Geotechnical Reports, Addenda, and LADBS Approval Letters

Geologic and Soils Engineering Exploration

1501 Marlay Drive

Response to City Correction Letter
1501 Marlay Drive
Lot 1, Tract 12204
Los Angeles, California

Figure 1

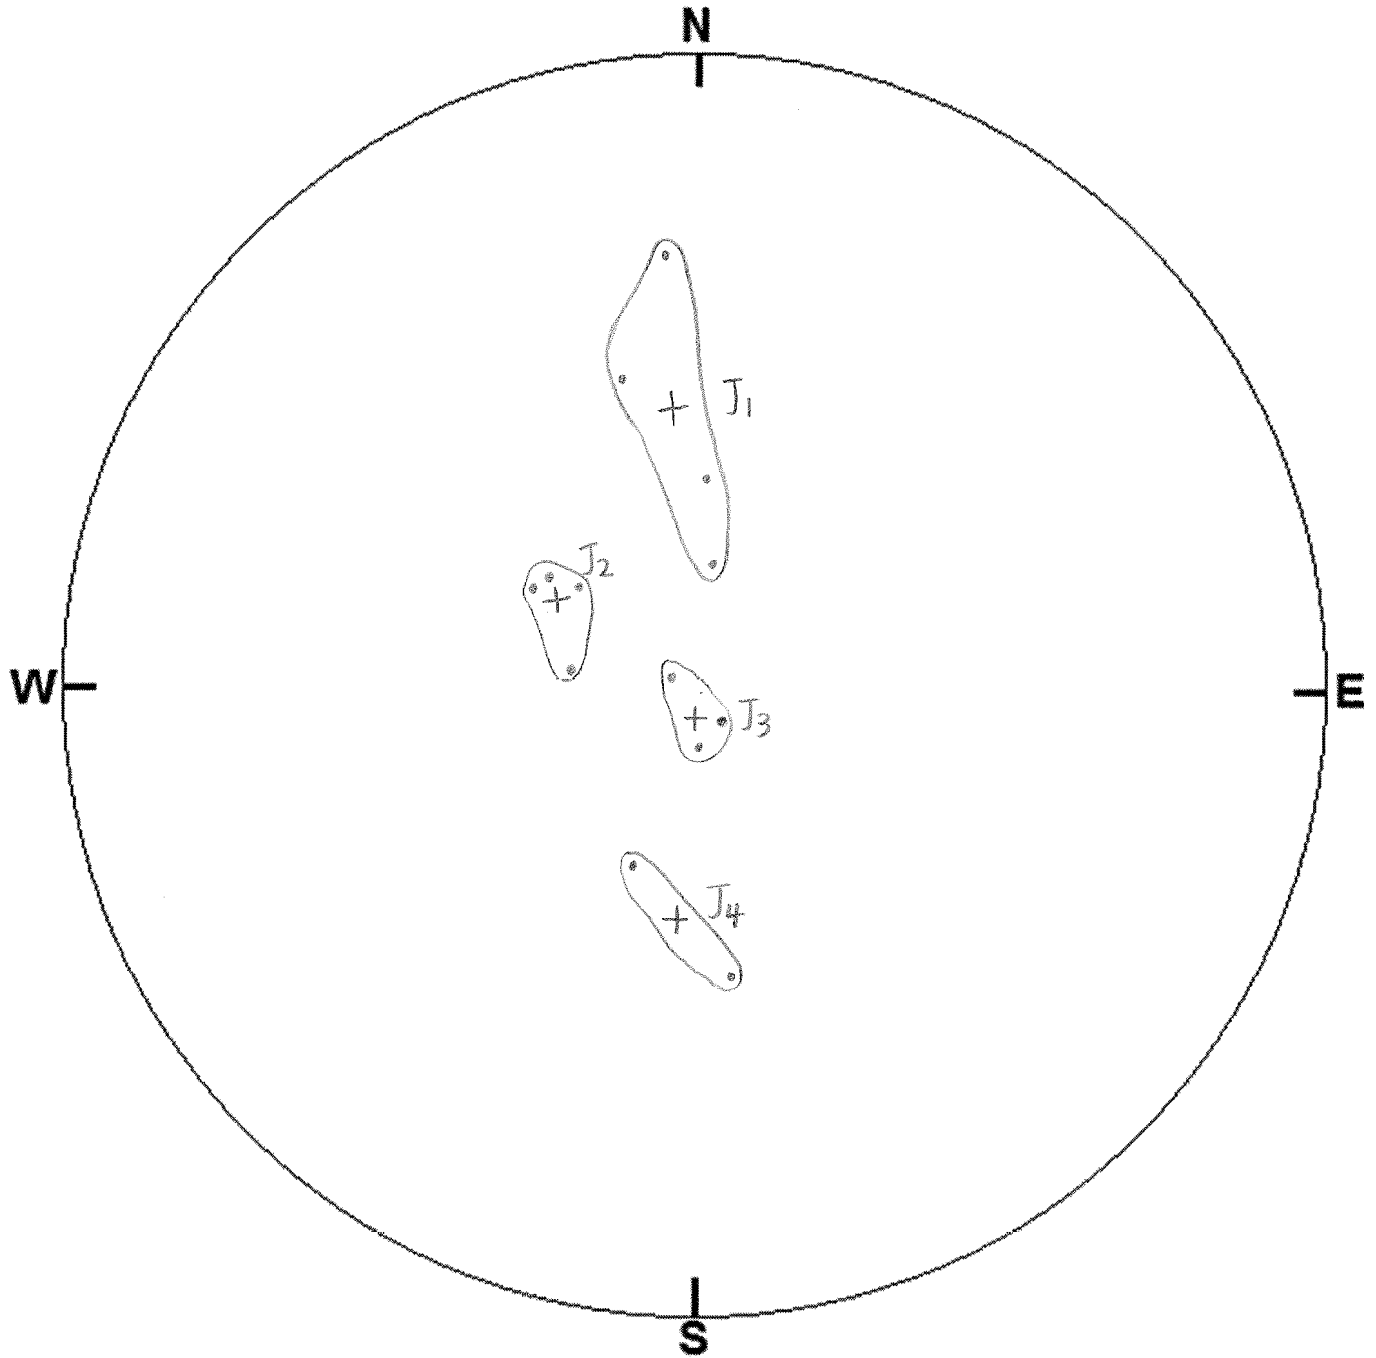
4. For rock slopes 1:1 (H:V) or steeper, provide additional geologic mapping and analysis that incorporates, but not limited to, the following:
 - a. Detailed mapping and description of discontinuities along the existing cut slope; such as bedding planes, lithologic contacts, joints, fractures, and faults, with characteristics such as orientation, spacing, presence of infilling or openness, continuity, etc.

- b. Kinematic analysis of discontinuities relative to the slope face, using stereographic methods to assess potential planar, wedge and topple type failures.

- b. The granitic rock exposed on the site is generally massive, however, has four major sets of joint planes (see enclosed Figure 1). The joint planes are weathered but no significant infillings. The joint planes have no measurable uniform spacing. No other continuous planes of structural weakness such as a fault plane or shear zones was observed on the ascending cut slope face.

The joint planes mapped on the slope face are stereo-projected on the equal-angle stereonet, as shown on Figures 1 and 2. Both mechanic feasibility analyses which qualitatively evaluate the potential of rock wedge failure and kinematic feasibility analyses which quantitatively evaluate the potential of rock wedge failure were performed. Four major joint sets are shown on Figure 1. As shown on Figure 2, most of potential rock wedges with potential sliding planes along the joint planes or sliding plunge along the intersections of joint planes are mechanically infeasible. However, the potential rock wedge failures sliding along the joint plane of joint set #4, the intersection line of joint sets #4 and #2, and the intersection line of joint sets #4 and #1 are mechanically feasible.

Figure 2

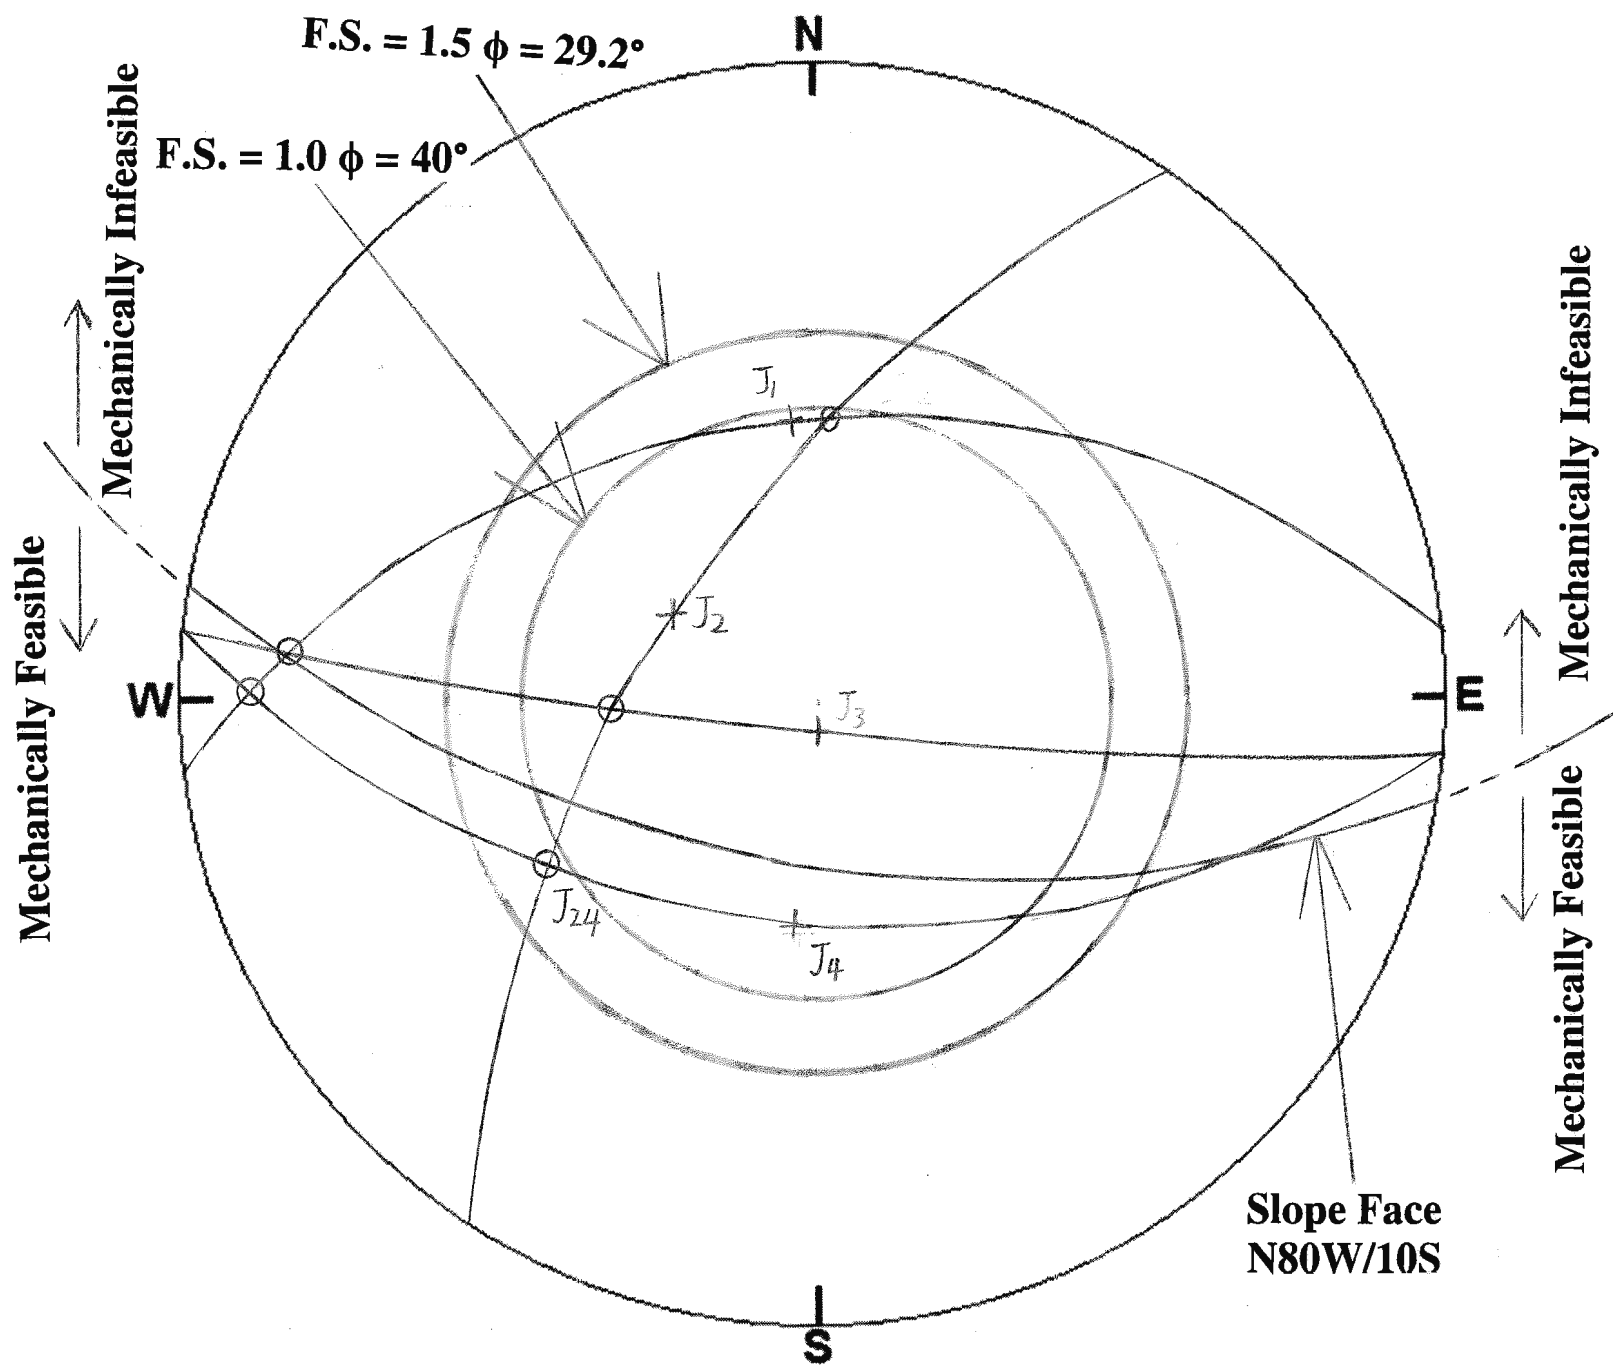
- c. Slope stability analysis of the potential failures using appropriate methods for type of failure identified from the kinematic analysis.
5. Verify the scale of the geologic map and indicate the correct scale on the map. Scaled measurements from the map do not correspond to the indicated map scale of 1" = 16'.

- c. Also as shown on Figure 2, the potential slide along the intersection line of joint sets #4 and #1 is kinematic infeasible due to its low dip angle. The kinematic study indicated that the potential rock wedge failure along the joint plane of joint set #4 has a factor of safety less than 1.0 and the potential rock wedge failure along the intersection line of joint sets #4 and #2 has a factor of safety between 1.0 and 1.5 (see Figure 2).

Although the stereographic projection analyses indicated potential rock wedge failures along the joint plane of joint set #4 and the intersection line of joint sets #4 and #2, the occurrence of a large rock wedge failure in a single event is low due to the low discontinuity of the joint planes and the weathering nature of onsite granitic rock. Instead of the occurrence of a large rock wedge failure in a single event, the rock wedge failure will act as a progressive failure of small rock wedges. Due to the weathering nature of onsite granitic rock and the city regulations that rock bolting can only be considered as a remedial mitigation measure for slope stabilization, the use of rock bolting for the subject project is not recommended. It is recommended that a high impact wall be constructed in the rear yard area to prevent the bouncing of small rock wedges over the top of the wall to damage the proposed single family residence and the rear yard steep ascending slope be protected by the installation of heavy duty wire netting on the slope face. The other purpose of the impact wall is to provide the proposed single family residence with the code required building clearance.
